Three Mile Island Nuclear Station, Unit II (TMI-2)
Operating License No. DPR-73
Docket No. 50-320
BOP Diesel Generators

BOP DIESEL - GENERATOR REMOVAL

Figure 1

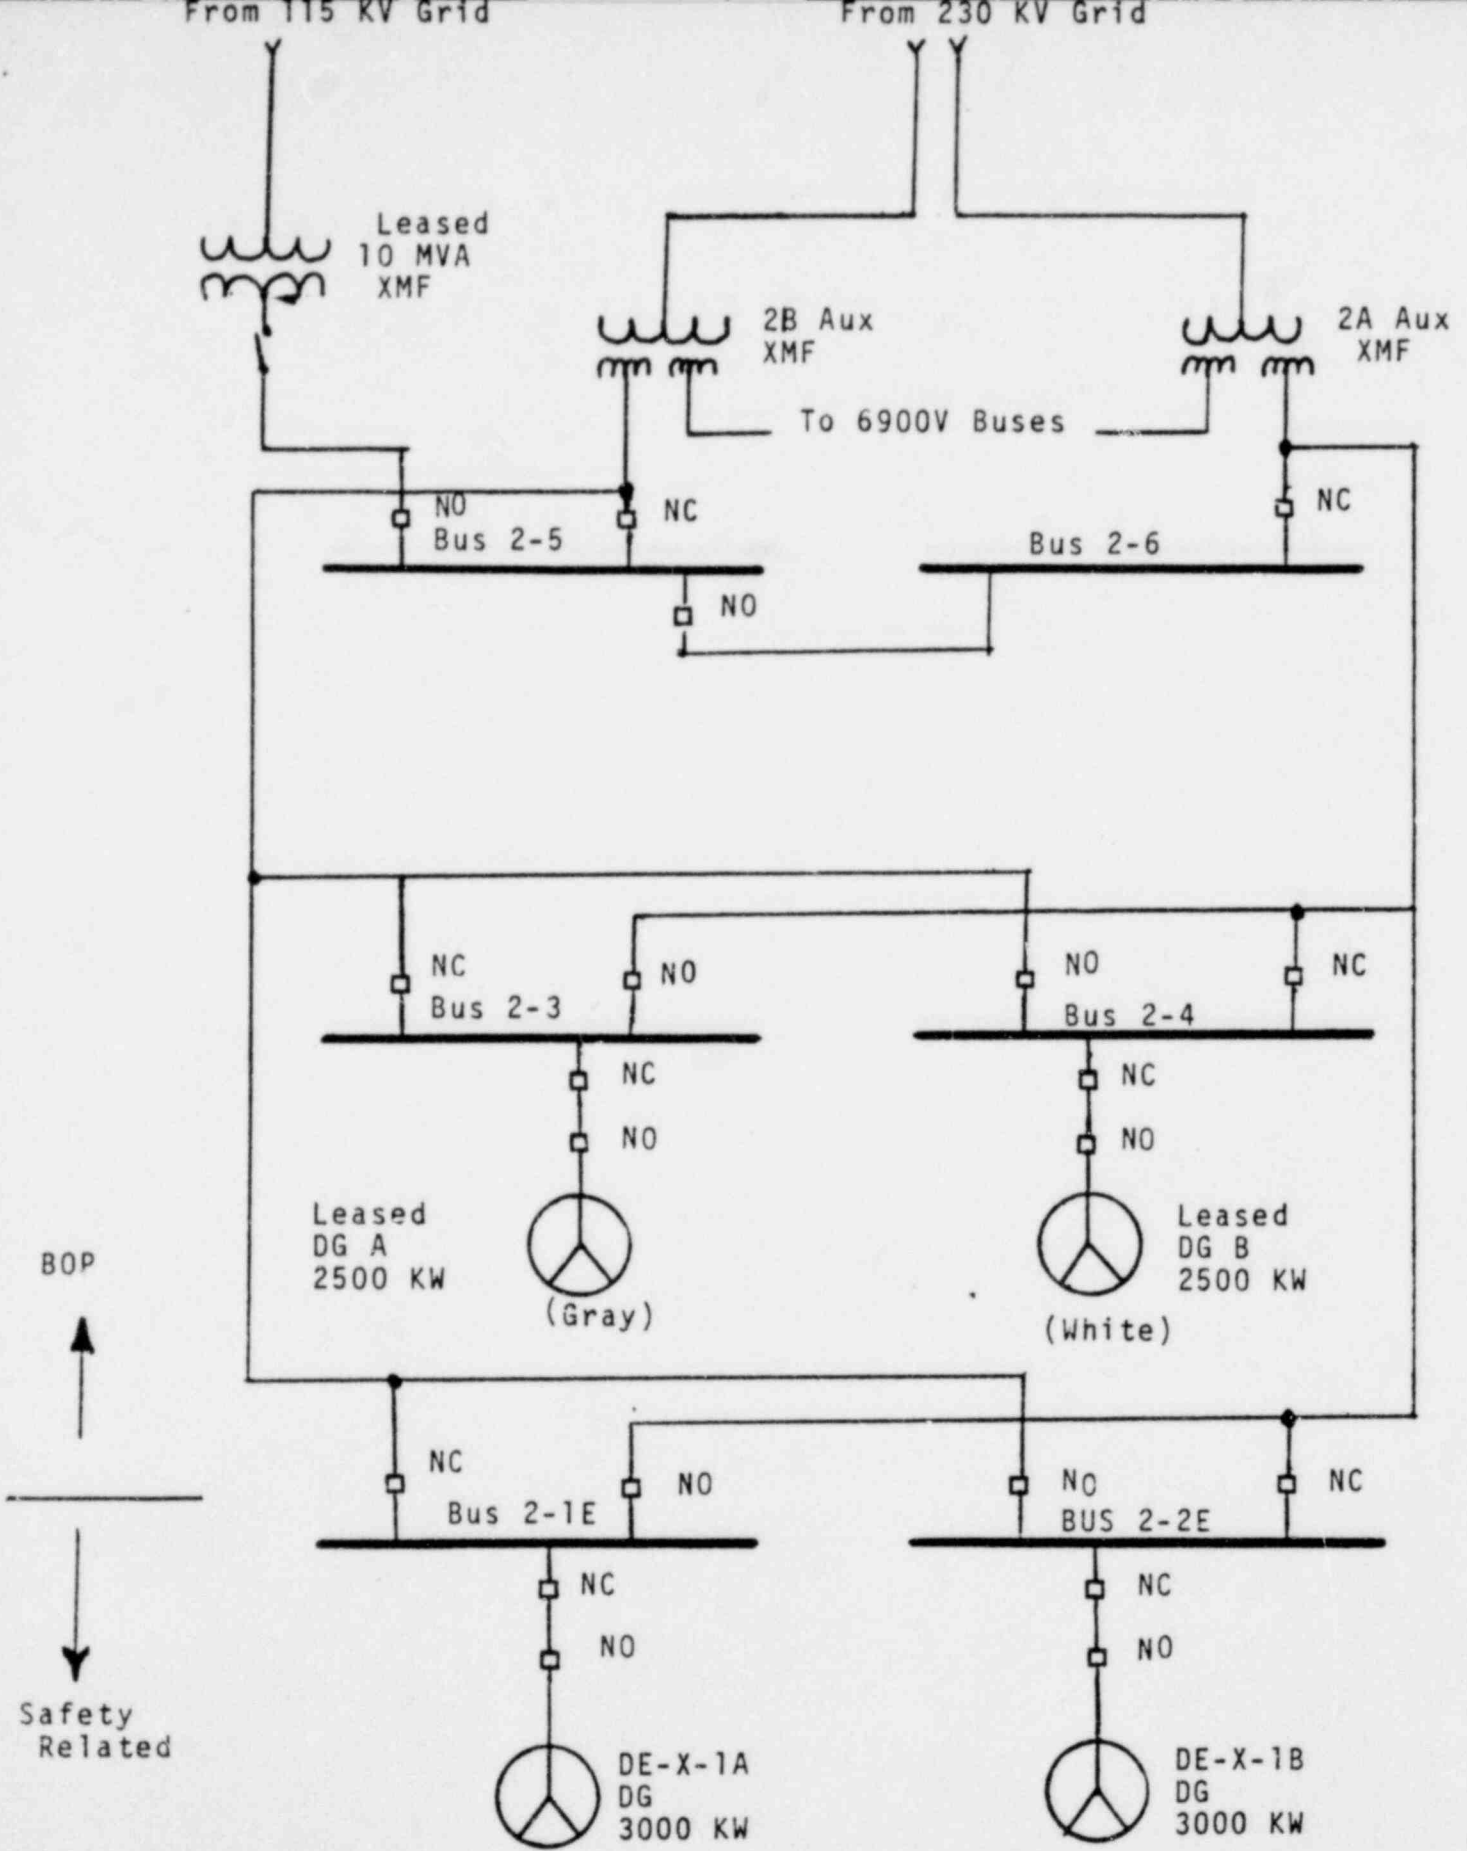
Following the accident at TMI-II, secondary plant equipment was utilized to provide the necessary core decay heat removal. To ensure a reliable source of power to this equipment in the event of loss of offsite power, additional 2500 kw diesel generators and 10MVA transformer was leased and installed as shown in Figure 1. The 10MVA transformer was connected to the 115 kv transmission grid which was separated from the normal 230 kv grid supplying the station auxiliary transformers. Since the 115 kv grid could be backed up by combustion turbines this source was considered equivalent to an onsite power supply.

Figure 2

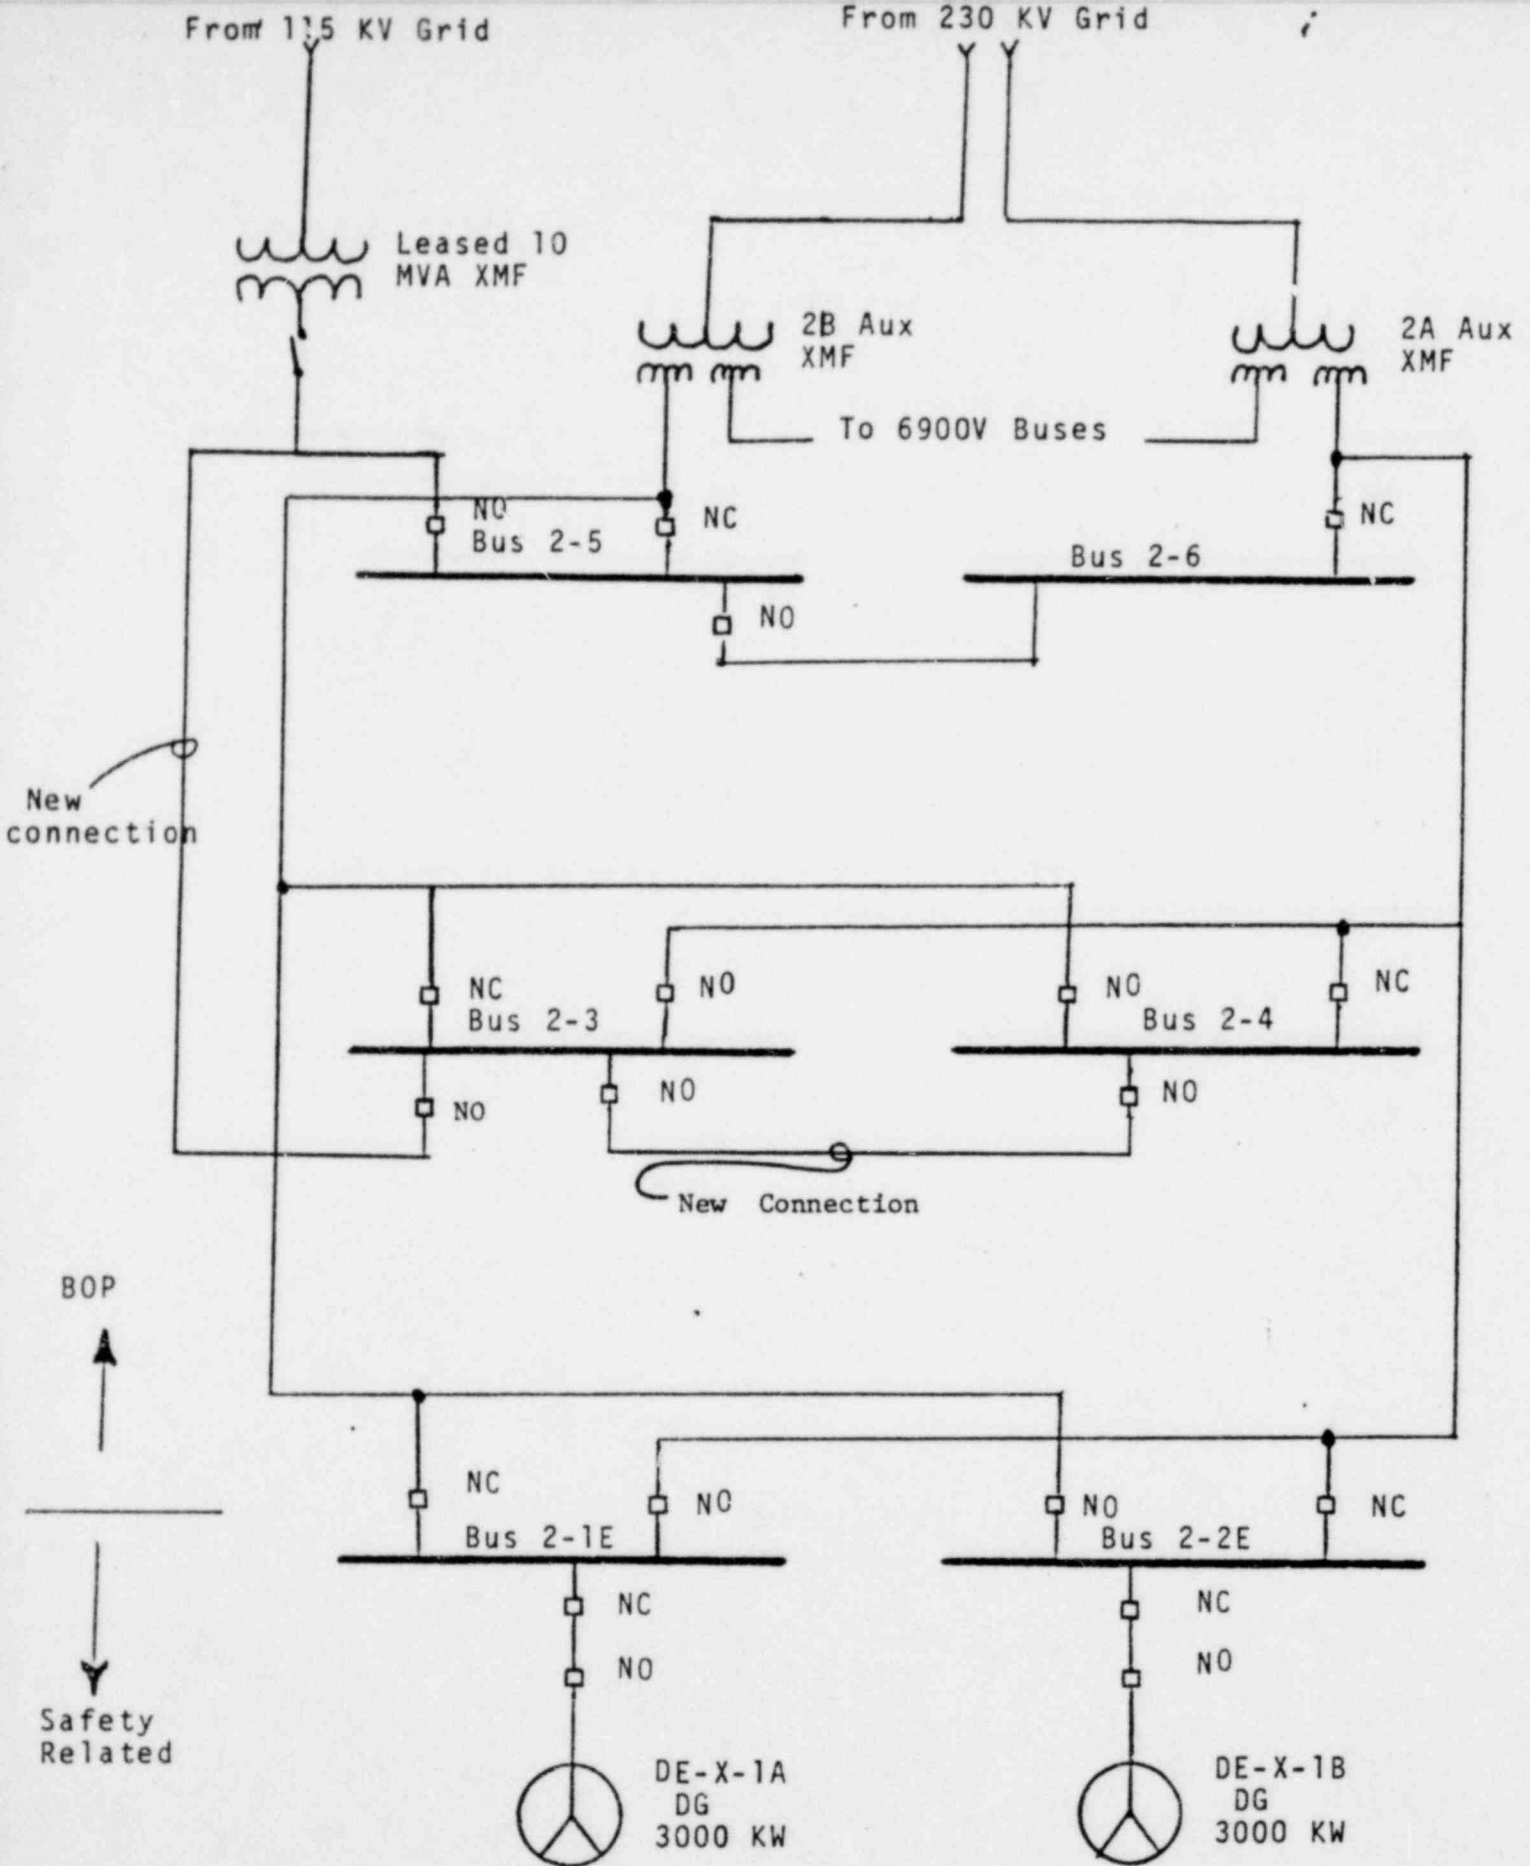
The technical approach to be taken to implement this proposed change will be to supply the non-vital busses from the 10MVA transformer that is supplied from the 115 kv, combustion-turbine powered bus. (Significantly, the combustion turbines have a "black start" capability.) To implement this technical approach it is necessary to install new connections as shown on Figure 2.
